**Subject: Palo Verde Nuclear Generating Station (PVNGS)
Units 1, 2, and 3 and Independent Spent Fuel Storage
Installation
Docket Nos. 50-528, 50-529, 50-530 and 72-44
License Nos. NPF-41, NPF-51 and NPF-74
Revision 51 to PVNGS Emergency Plan**

REVISION 51

DESCRIPTION OF CHANGES

**FIGURE 12 - DEMOGRAPHY WITHIN THE PLUME EXPOSURE PATHWAY
EMERGENCY PLANNING ZONE**

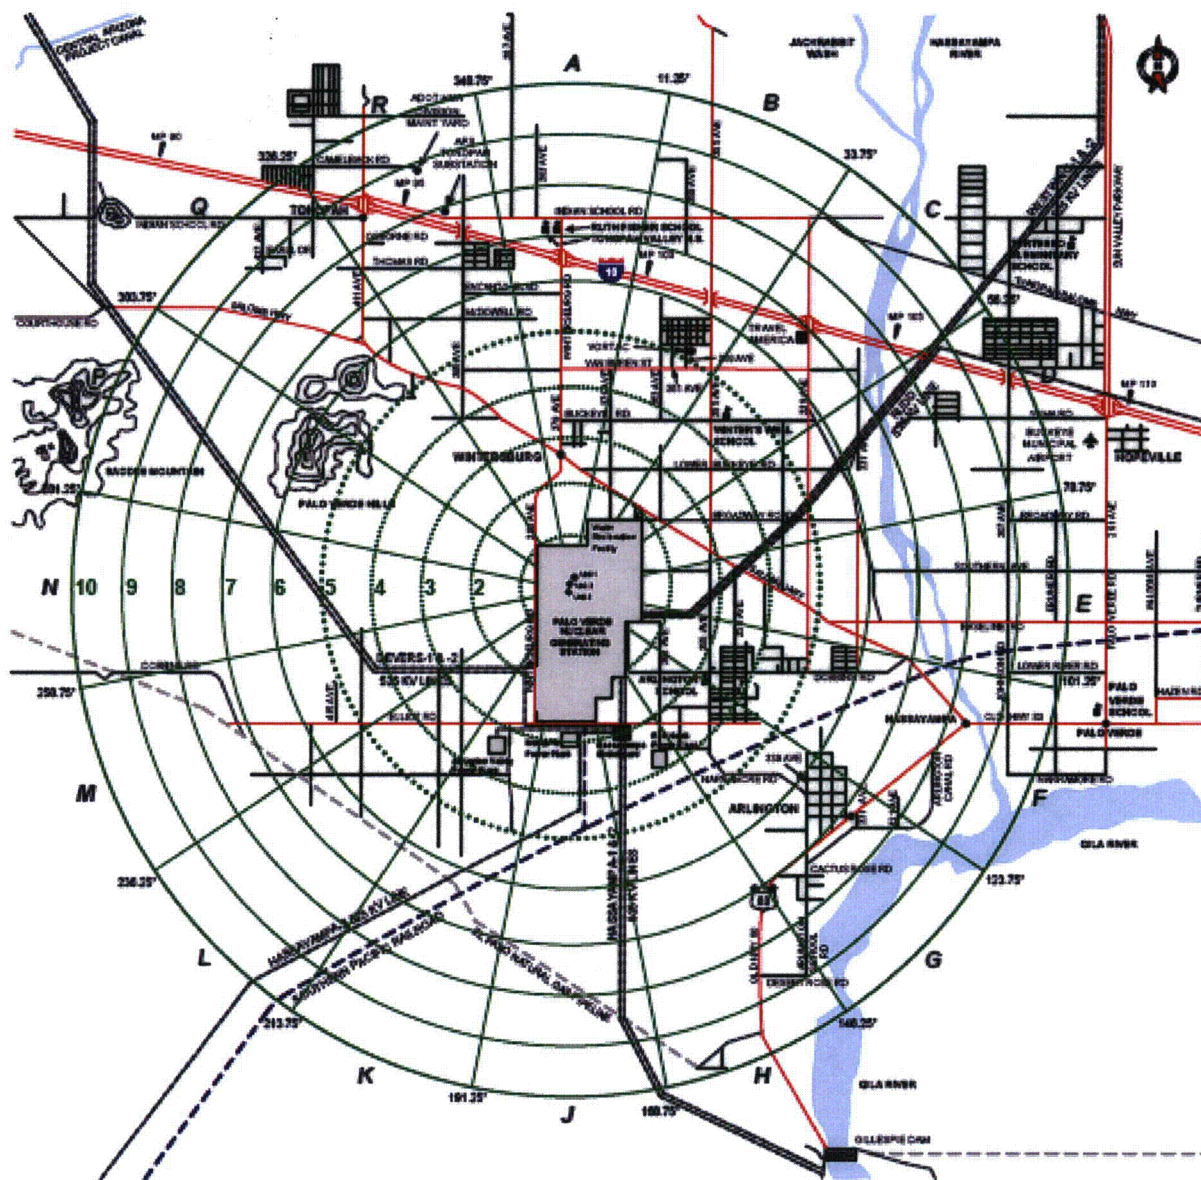
9. Figure 12, Demography Within The Plume Exposure Pathway Emergency Planning Zone, added new Palo Verde Population Survey data for December 2013.....107
